**SUBJECT: Temporary Design Bulletin C02-08
Effective April 16, 2002**

This bulletin supersedes Temporary Design Bulletin C02-03.

FDOT NOISE WALL PILE/POST CONNECTION OPTIONS – GENERAL NOTES (Page 1 of 2)

FDOT NOISE WALL PILE/POST CONNECTION - OPTION NO. 1A (Page 1 of 2)

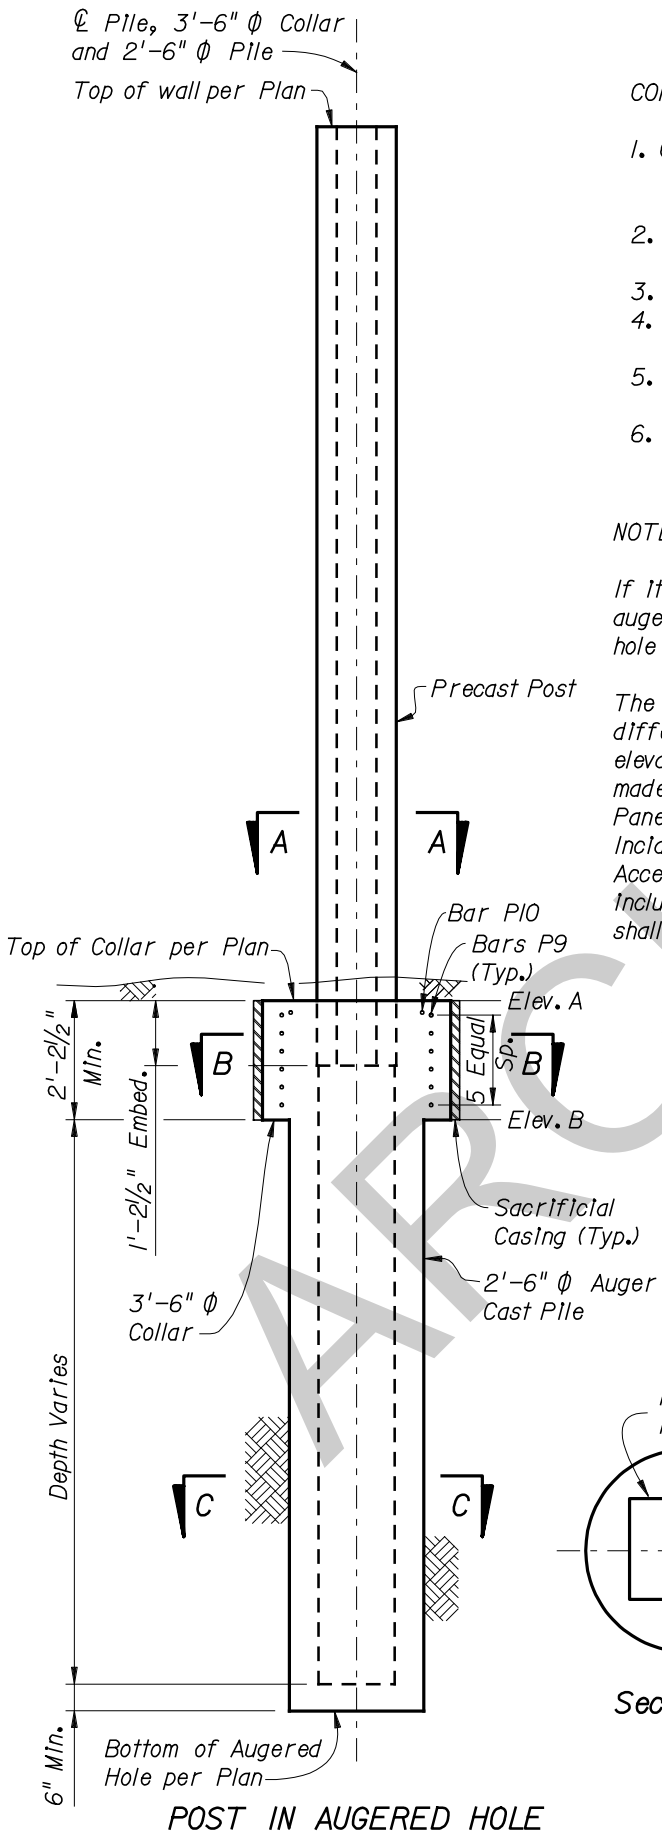
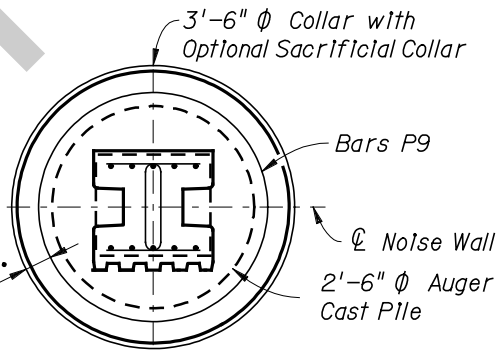
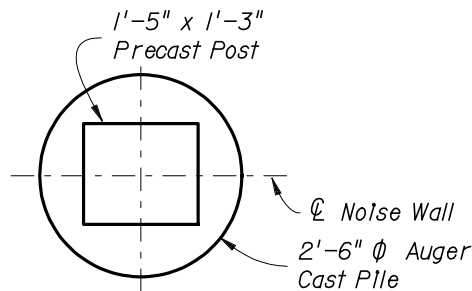
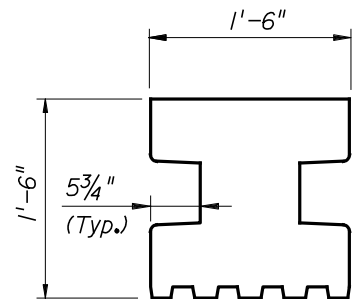
Option 1A

Requires casting concrete around the reinforcement cage extending below the bottom of the post, prior to setting the post into the auger cast pile. The rectangular section shown on page 2 of 2 of Option No. 1A may be replaced with the post H-section shown in Section E-E. If used, contractor shall provide additional P1 bars, as required, in lieu of the P2 bars shown for the rectangular section.

1. Cast the concrete H Post and a 1'-5" x 1'-3" rectangular pile around the rebar below the H Post section using 1" of cover. See post detail on Page 2 of 2.
2. Temporarily excavate to Elev. B in the vicinity of the post. Drill and cast a 2'-6" φ auger cast pile. Fill the augered hole to Elev. B.
3. Place the sacrificial casing or collar form and collar reinforcement.
4. Construct a template to support and properly align the pile in the correct location in the 2'-6" φ hole.
5. Plunge the pile into the 2'-6" φ hole. The bottom of the H Post section (see section A-A) shall be 1'-2 1/2" below Elev. A (Top of Collar).
6. Finish the concrete to Elev. A (Top of Collar).

FDOT NOISE WALL PILE/POST CONNECTION - OPTION NO. 1B (Page 1 of 2)

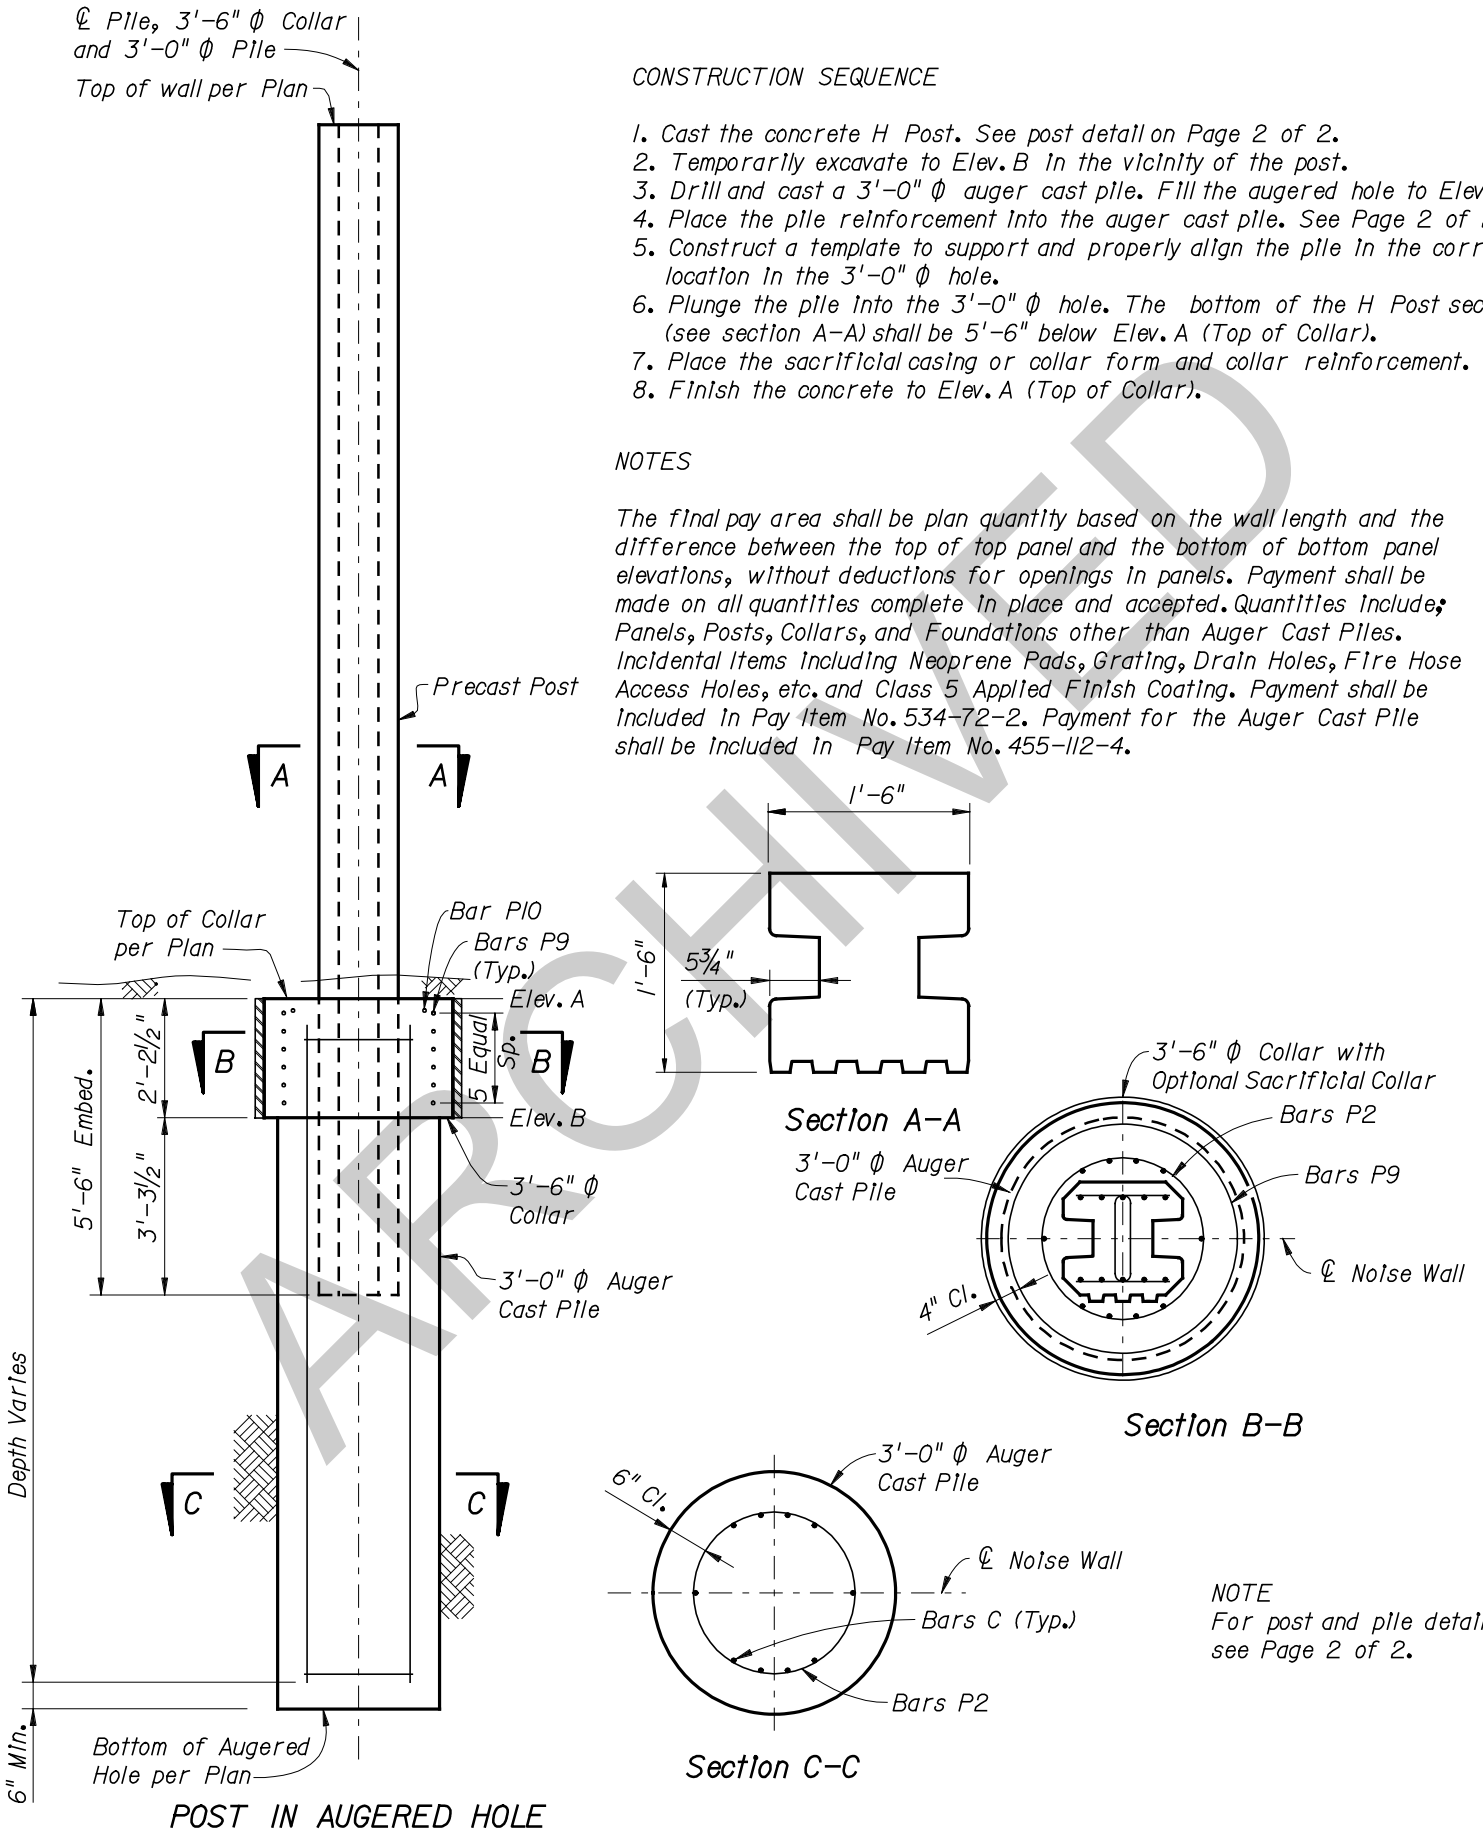
Option 1B

Requires casting the concrete post an additional five (5) feet below the bottom of the post, using the modified section shown in Section F-F on page 2 of 2 of Option No. 1B. Reinforcement Bars A and B in the post shall be cut off five (5) feet below the bottom of post and disposed of by the contractor. The additional reinforcement, shown in the Augured Pile Reinforcement Detail shall be as follows:

1. Cast the concrete H Post. See post detail on Page 2 of 2.
2. Temporarily excavate to Elev. B in the vicinity of the post.
3. Drill and cast a 3'-0" ϕ auger cast pile. Fill the augered hole to Elev. B.
4. Place the pile reinforcement into the auger cast pile. See Page 2 of 2.
5. Construct a template to support and properly align the pile in the correct location in the 3'-0" ϕ hole.
6. Plunge the pile into the 3'-0" ϕ hole. The bottom of the H Post section (see section A-A) shall be 5'-6" below Elev. A (Top of Collar).
7. Place the sacrificial casing or collar form and collar reinforcement.
8. Finish the concrete to Elev. A (Top of Collar).

FDOT NOISE WALL PILE/POST CONNECTION - OPTION NO. 1B (Page 2 of 2)

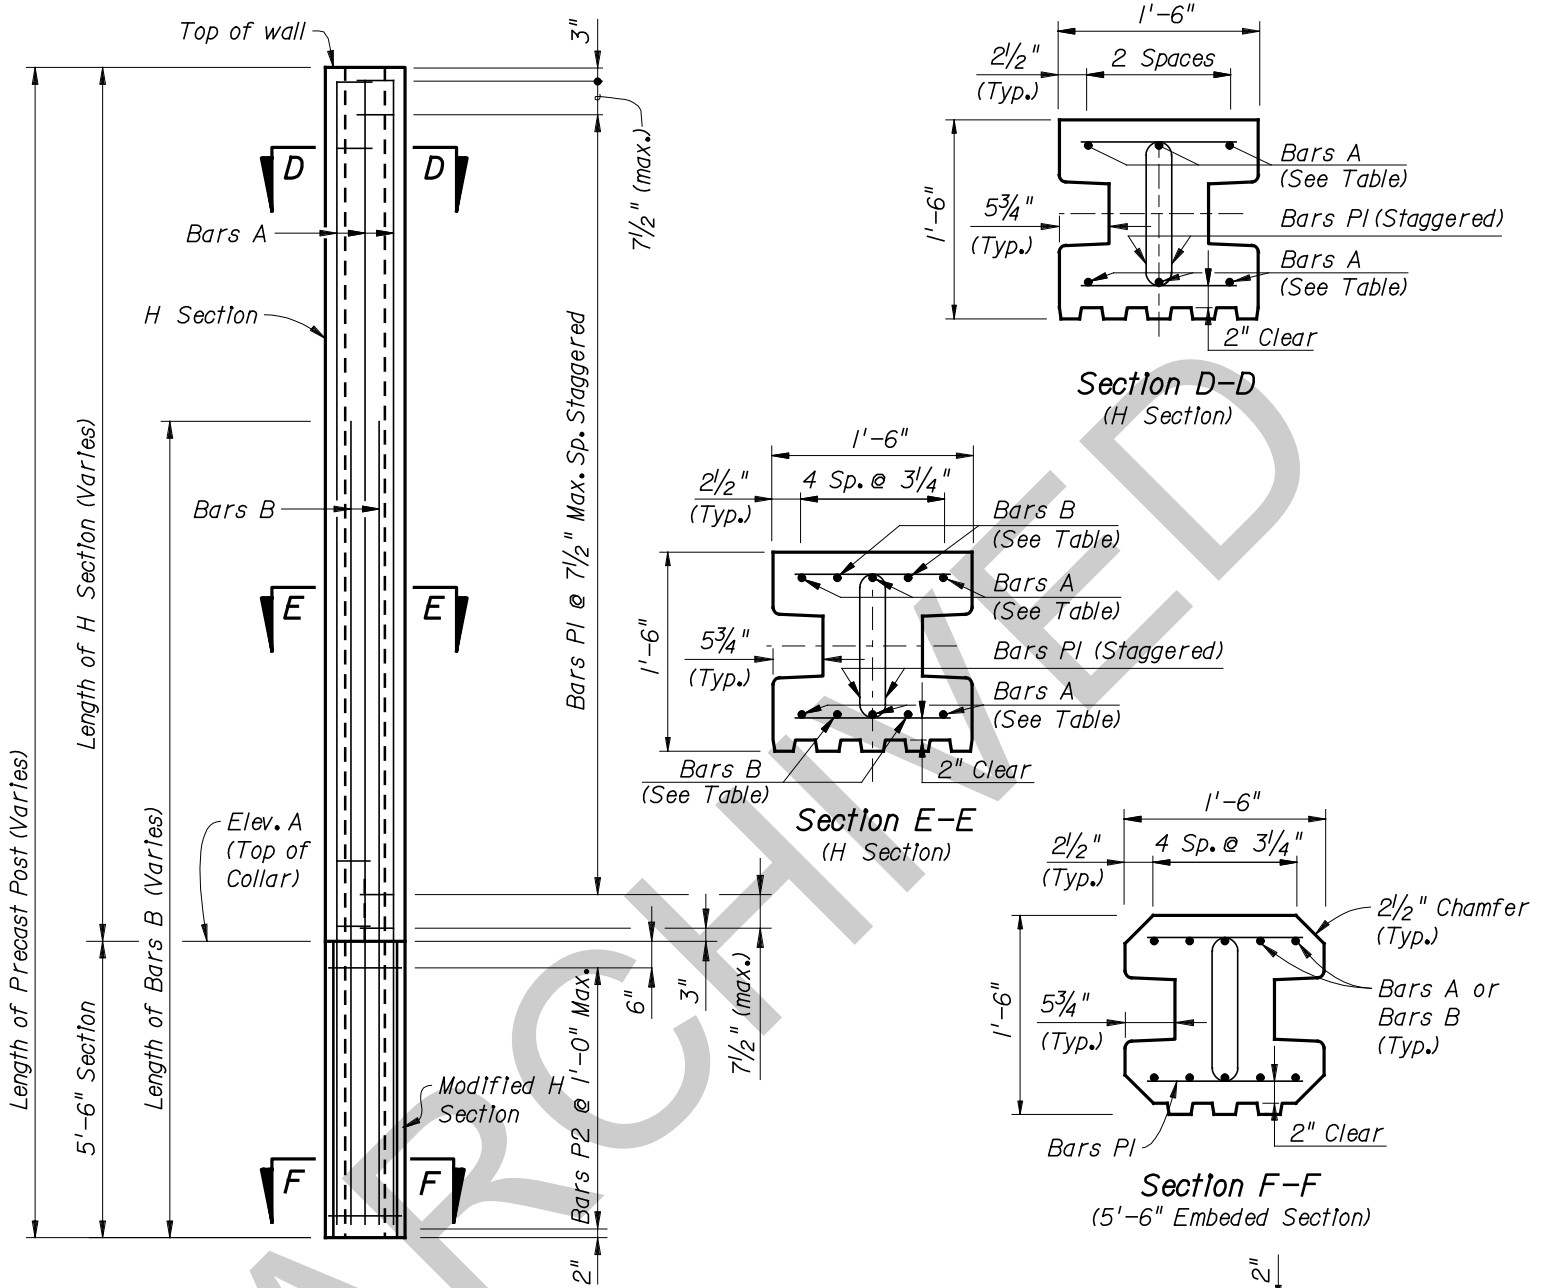
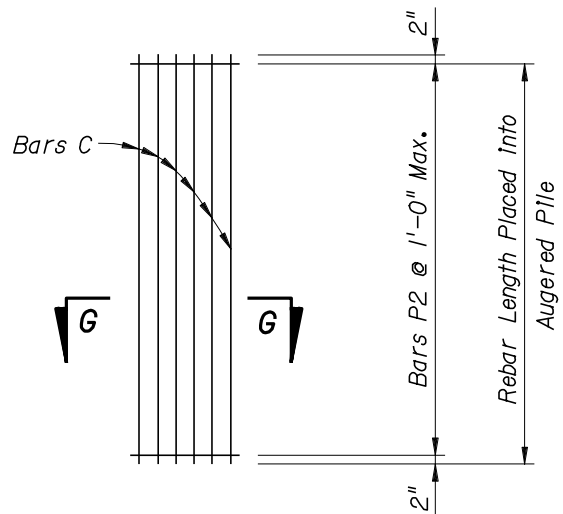
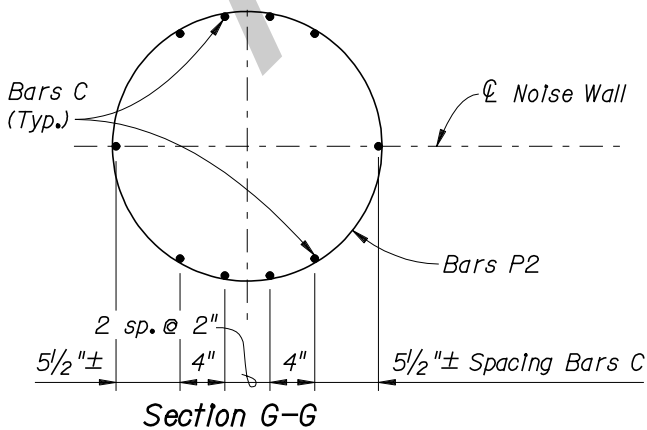
Bars C shall be number 8 bars and shall extend from 6 inches above bottom of augured hole to 4 inches below top of collar. Bars P2 shall be number 4 bars, 7'-7" long and bent to a 1-0/2" radius.

FDOT NOISE WALL PILE/POST CONNECTION - OPTION NO. 2A (Page 1 of 2)

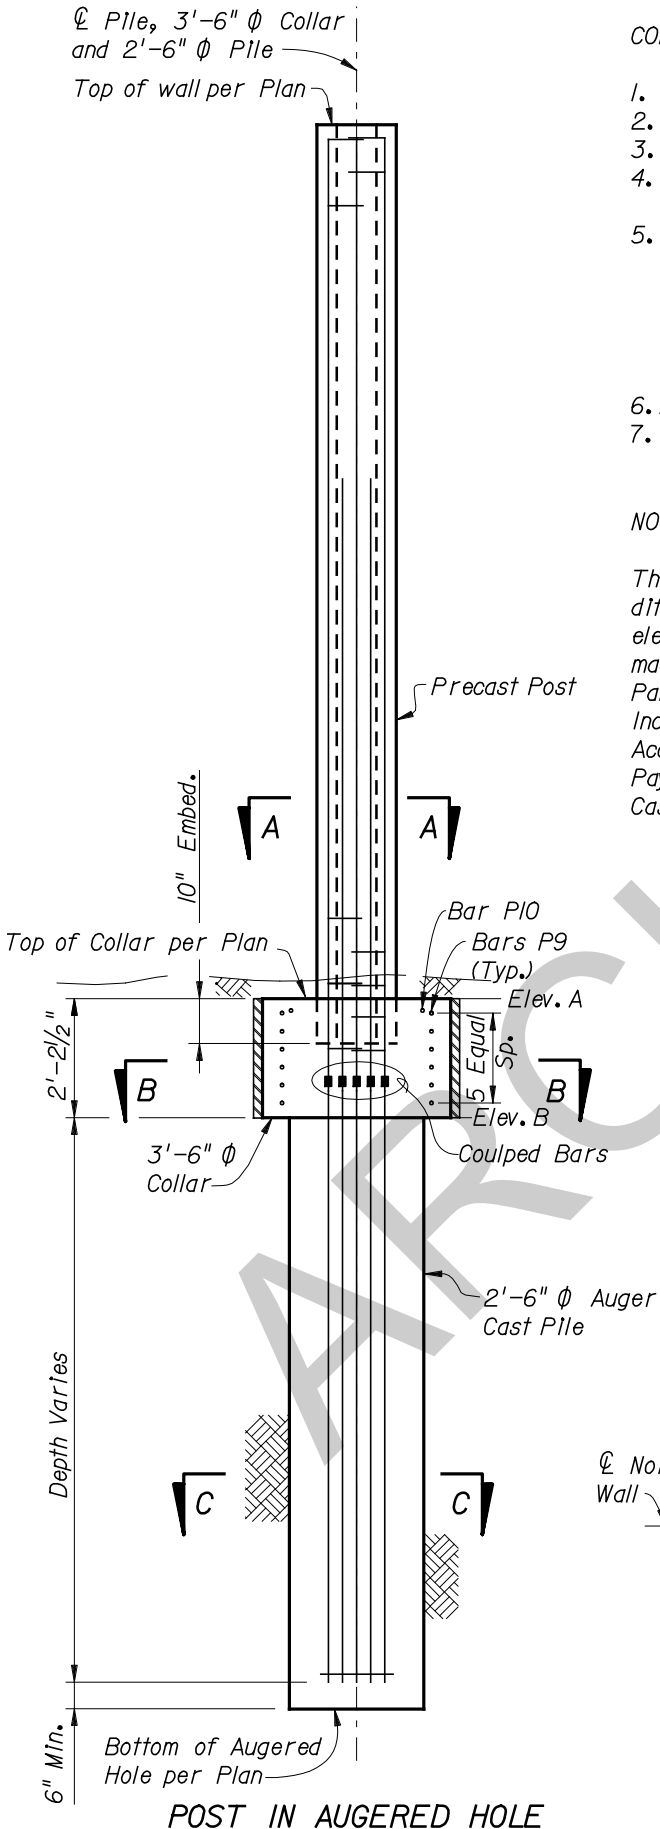
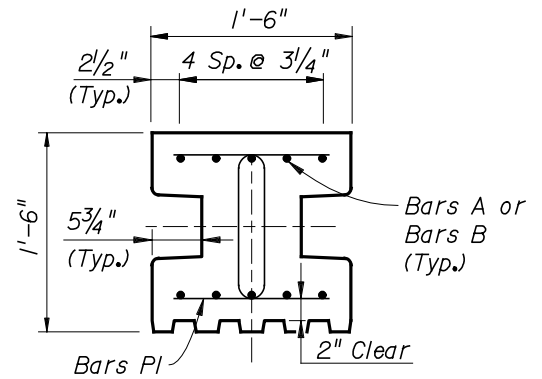
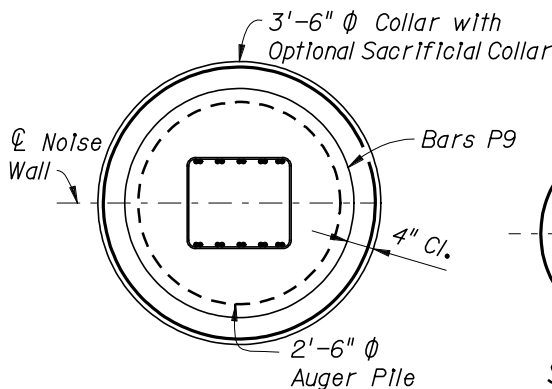
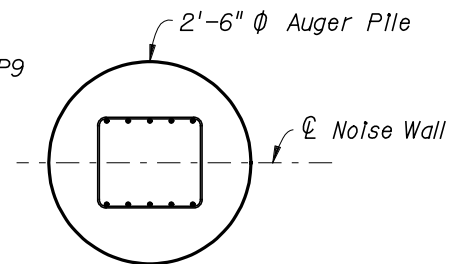
Option 2A

Requires cutting reinforcement Bars A and B in the post 8/4" minimum below the bottom of post. The cut-offs of Bars A and B shall be used as Bars C to form a cage using the P2 tie bars. The bar cage shall be lowered into the auger cast pile and carefully positioned to allow for coupling Bars C with Bars A and B, at the base of the post, with mechanical couplers.

1. Cast the concrete H Post. See post detail on Page 2 of 2.
2. Temporarily excavate to Elev. B in the vicinity of the post.
3. Drill and cast a 2'-6" ϕ auger pile to Elev. B.
4. Place the rebar into the 2'-6" ϕ augered pile hole. See augered pile reinforcement Page 2 of 2.
5. Construct a template to properly align the precast post over the augered pile. Using mechanical couplers splice the precast post rebar with the rebar in the augered pile. The Contractor shall splice bars prior to placing pile reinforcement. Attachment and alignment may be made prior initial set of pile grout. The bottom of the H Post section (see section A-A) shall be 10" below Elev. A (Top of Collar).
6. Place the sacrificial casing or collar form and collar reinforcement.
7. Construct a 3'-6" ϕ collar to cover the mechanical splice. Cast the concrete collar and finish the concrete to Elev. A (Top of Collar).
